SOUTH CAROLINA ELECTRIC & GAS COMPANY

February 6, 1985

Subject: Virgil C. Summer Nuclear Station
Docket No. 50/395
Operating License No. NPF-12
Request for Additional
Information - Cable Separation

Table 4-1

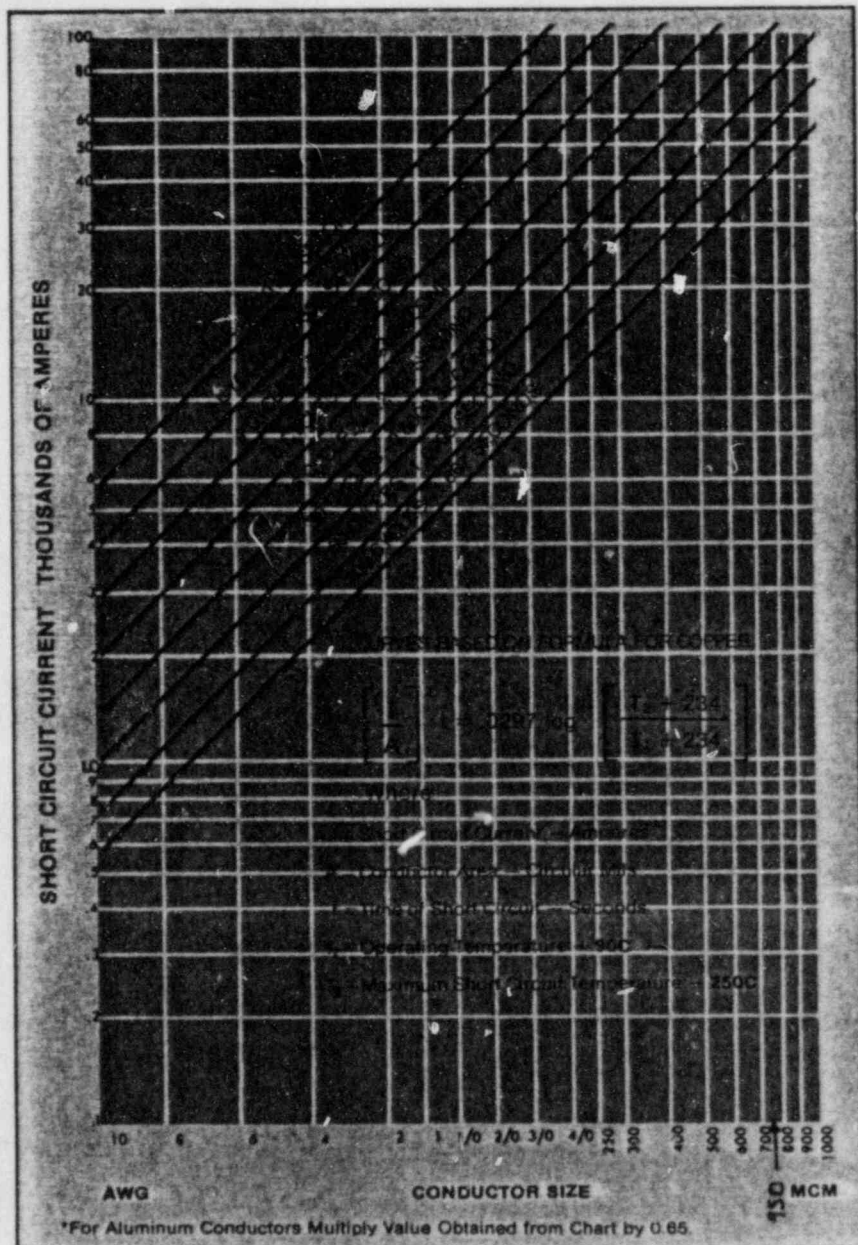
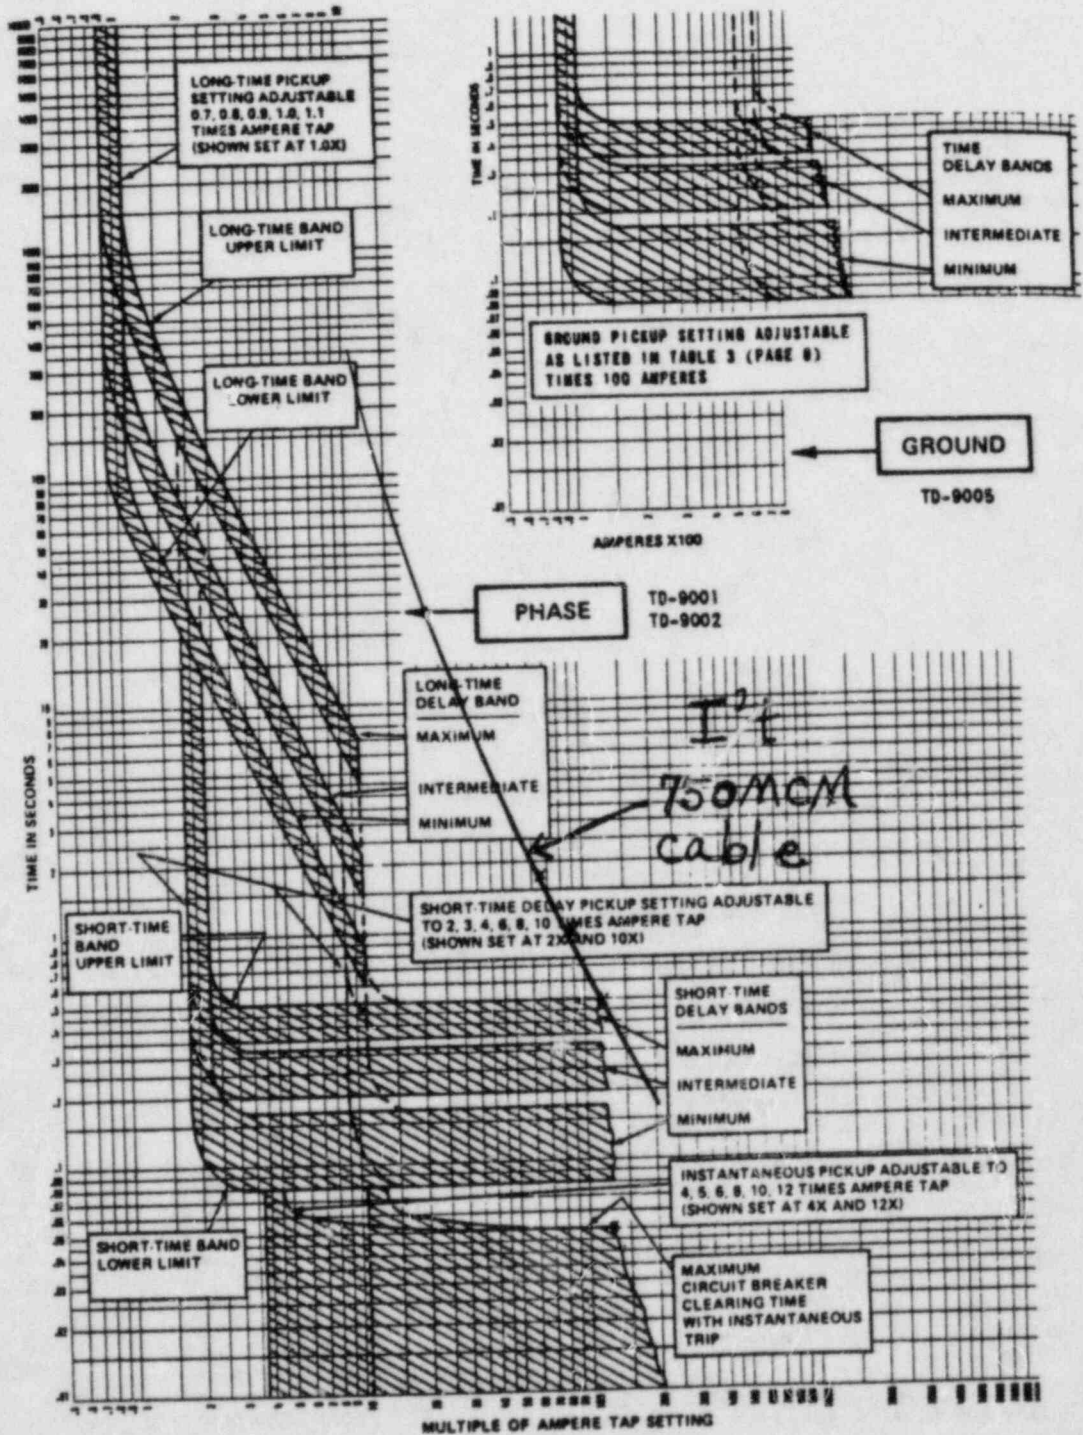
1. Your letter of November 29, 1984 does not demonstrate that the associated cable protective device will clear the imposed fault condition without exceeding the I^2t rating of the cable (before the ignition temperature of the cable insulation is reached). Therefore, provide for Staff review some typical protection device curves for the subject circuits plotted against the I^2t curve of the cable which it protects.
2. For all of the subject circuit cables protected by overcurrent protective devices, are those cables protected equal to or better than their I^2t curves?

From Reference #1, the short circuit allowable amperes for various times for 750 MCM cable were determined. Reference #1 is an Allowable Short Circuit Current table taken from a cable design handbook. These values of allowable short circuit amperes for the cable were then plotted on the Time-Current Characteristics curves for the breaker; Reference #2. From this plot it is evident that the breaker will trip before the I^2t of the cable is reached.

From Reference #1, the short circuit allowable amperes for various times for 1/0 cable were determined. These values of allowable short circuit amperes for the cable were then plotted on the Characteristic Tripping Curve for the FA 100 Ampere breaker; Reference #3. From this plot it is evident that the breaker will trip before the I^2t of the cable is reached.
